SEWAGE DISPOSAL TESTING

MEMORANDUM

RE: 6718 Mink Hollow Rd.
Highland, MD 20777
"Before BP Approval"

I have reviewed the Building Permit B16004604 and before I can approve this permit the following requirements must be met.

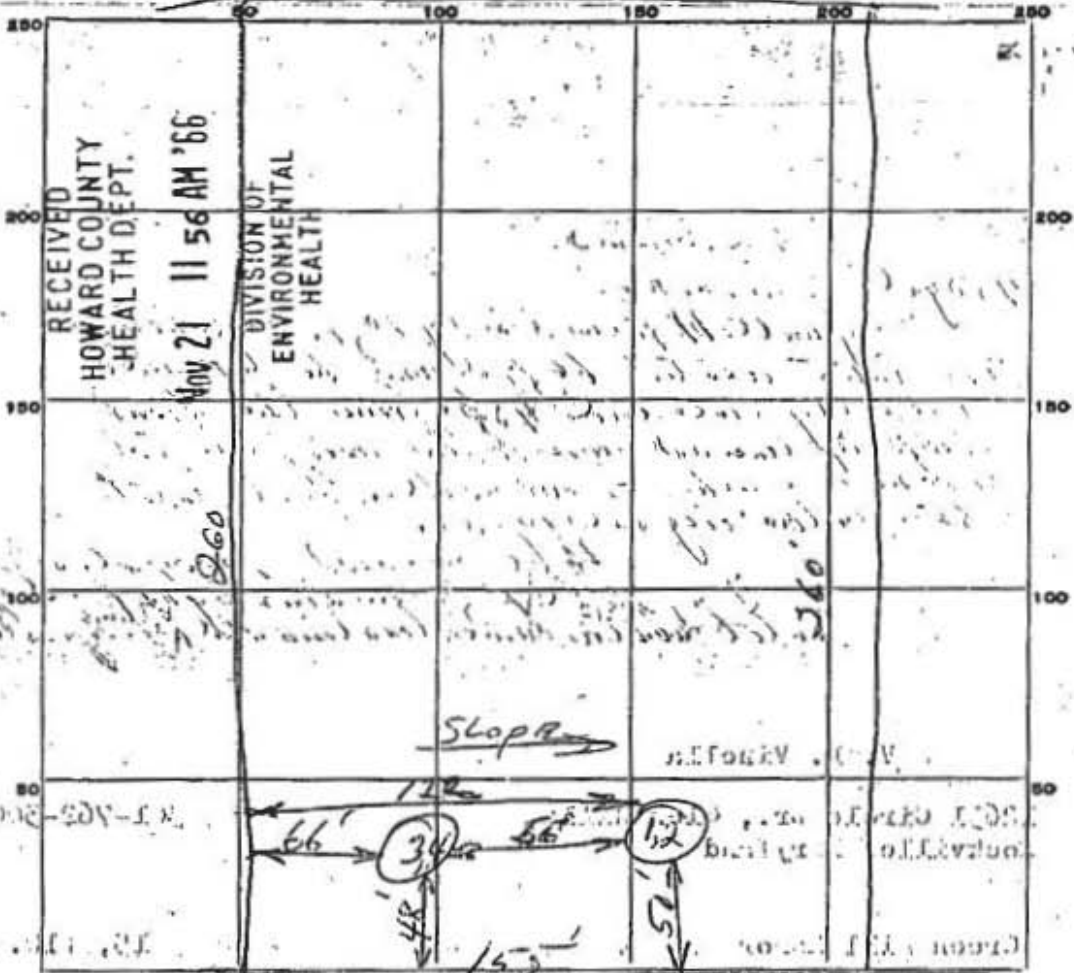
Use hole (3.4) for dry well.
